UNITED STATES PATENT AND TRADEMARK OFFICE

APPLICATION NO.	FILING DATE	FIRST NAMED INVENTOR	ATTORNEY DOCKET NO.	CONFIRMATION NO.
10/816,097	04/01/2004	Jeffrey Jackson	Jackson.1002	9486
57449 7590 11/01/2007 SHEEHAN PHINNEY BASS & GREEN, PA c/o PETER NIEVES 1000 ELM STREET MANCHESTER, NH 03105-3701			EXAMINER LE, TAN	
			ART UNIT 3632	PAPER NUMBER
			MAIL DATE 11/01/2007	DELIVERY MODE PAPER

Office Action Summary

DETAILED ACTION

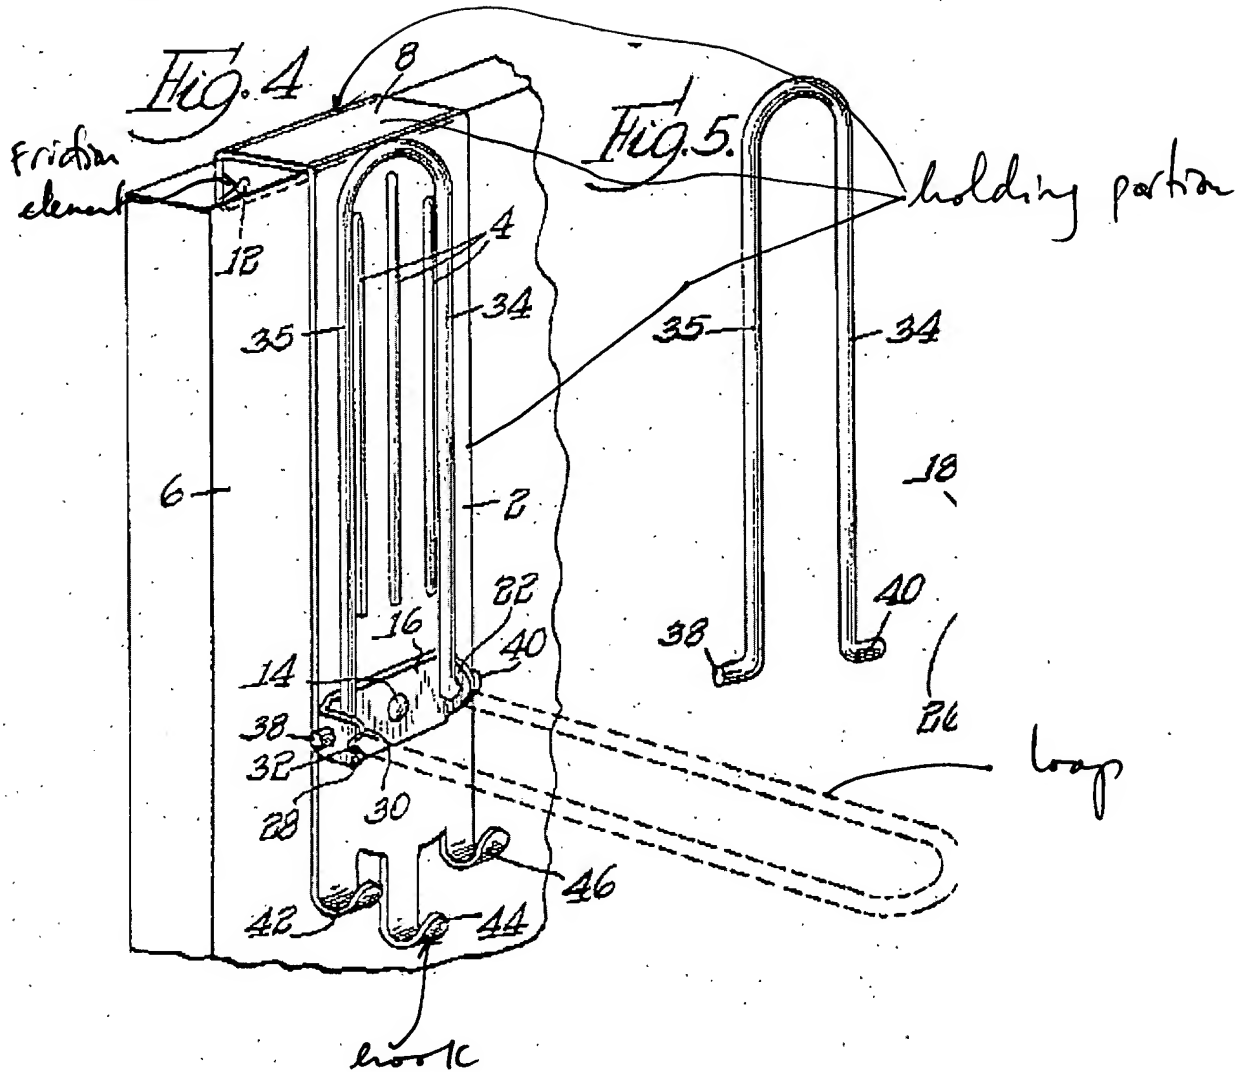
As to claim 9, Larson teaches a hanger apparatus (see attached Fig. 4 below) comprising a holding portion (2, 8) shaped so as to allow said apparatus to hold to said structure by an underside portion (under 8) of said holding portion being capable of resting not only on horizontal planar surface said structure; a frictional element (12) affixed to said underside portion and positioned on said holding portion to be in contact not only with said horizontal surface whereby said frictional element reduces mobility of said holding portion along said horizontal planar surface; and an enclosed central loop (34, 35) enclosed on top portion, a bottom portion, a front portion, and a back portion of said enclosed central loop, said back portion of said enclosed central loop being a portion of said holding portion, and said enclosed central loop being open on a left side portion and a right side portion of said enclosed central loop; a hook being an extension of said back portion of said enclosed central loop, said hook being capable of allowing

As to claim 13, wherein said holding portion has a shape that is capable of resting on a mantle. Note that the mantle shape is not defined and is not claimed. The shape of the holding portion is clearly capable of resting on the mantle such as portion (8) can be resting on the mantle.

As to claim 20, wherein said holding portion contains an elongated top portion (8) and an elongated side portion (2), said elongated side portion extending in a direction substantially perpendicular to said elongated top portion, a portion of said elongated side portion being said back portion of said enclosed central loop.

As to claim 21, claim 21 is substantially similar to claim 9, is therefore also read on Larson, which includes means for holding (8) to said structure; means for gripping (12) for enhancing the grip of said means for holding on said structure; and means for maintaining a second object in said apparatus (an enclosed loop) (see attached figure), said means for maintaining being enclosed on top portion, a bottom portion, a front portion and a back portion, said back portion of said means for maintaining being a portion of said means for holding, and said means for maintaining being open on a left side portion and a right side portion of said means for maintaining; and means for hanging (hook 44 for example) being capable of allowing a first object to hang from said apparatus, said means for hanging being an extension of said back portion of said

Larsen. It is therefore believed that this rejection should now be removed for amended claim 9", the examiner disagrees. As pointed out in the office action and as illustrated on Fig. 4 attached. Larson's projection 12 reads on as the friction element, which is affixed to said underside portion as claimed. Note that Larson's projection 12 presses into the wood to prevent inadvertent removal along not only a horizontal plane but also a vertical plane. This projection 12 is affixed to the underside portion of the holding portion and does a function which considers equivalent to a frictional element function as Applicant claimed. It should also be noted that Applicant's remarks with respect to Figures 7-9 for the limitation "frictional element" is not what Examiner indicated in the office action.
